Report: TAB Report
Function: Test, Adjust, & Balance
Date: 11/14/2024
Completed By: National TAB

PROJECT
11-11-24 WAWA #5452 ORLANDO, FL

Project: 11-11-24 WAWA #5452 ORLANDO, FL

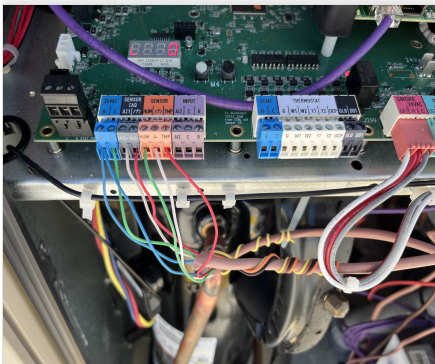
Issue Name : EF-1 Missing Backdraft Damper
Description : There is no backdraft damper installed in the EF-1 drop.
Created By : National TAB **Assigned To :** National TAB - Stephen Tassinaro
Status : Open
Priority : Medium **Asset Tag :**
Originated Date : 11/13/2024 - Stephen Tassinaro - National TAB

- **11/15/2024 National TAB - Stephen Tassinaro**
 - Unable to confirm if backdraft damper was added when curb adapter was installed. Fan was jammed onto the curb adapter and NTi tech was unable to separate without risking damage to fan.

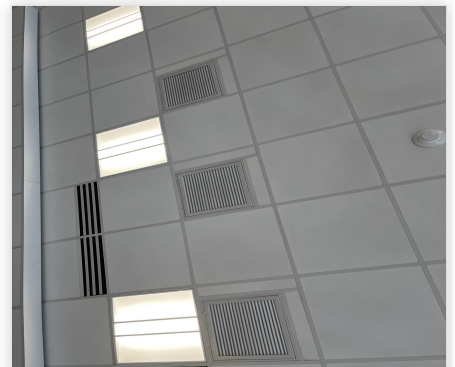
Issue Name : RTU Return Grille Sizing
Description : All RTUs call for G-1 return grilles. A G-1 air device is specified to have a 20"x20" neck and a face size of "NECK+3-3/4". The installed grilles are undersized and measure ~17"x17", with an open area of ~15.5"x15.5".
Created By : National TAB **Assigned To :** National TAB - Stephen Tassinaro
Status : Open
Priority : High **Asset Tag :**
Originated Date : 11/14/2024 - Stephen Tassinaro - National TAB

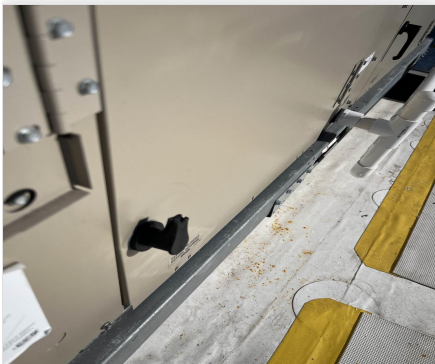
Issue Name : RTU-1 Broken Handle
Description : RTU-1 has a broken handle on the filter access door. Recommend replacement.
Created By : National TAB **Assigned To :** National TAB - Stephen Tassinaro
Status : Open
Priority : Low **Asset Tag :**
Originated Date : 11/13/2024 - Stephen Tassinaro - National TAB

Asset: RTU1

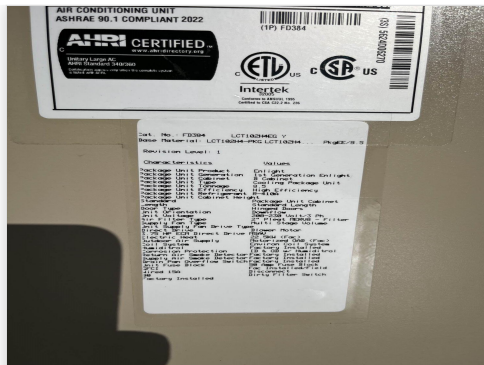
* Outside air hood not installed. Outside air damper set to a reasonable starting point but will need to be adjusted once hood assembly is installed. Static pressures to be taken once outside air is finalized.

Asset: EF1

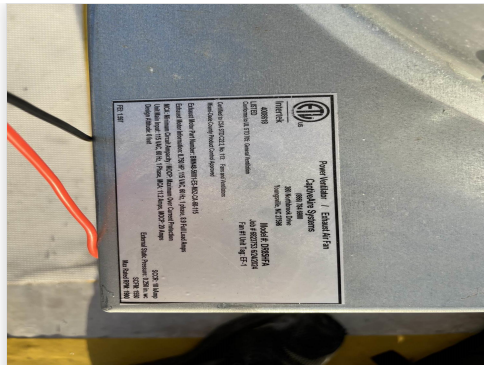
Notes:
*Fan jammed onto curb adapter and could not be lifted to take static pressure measurement.
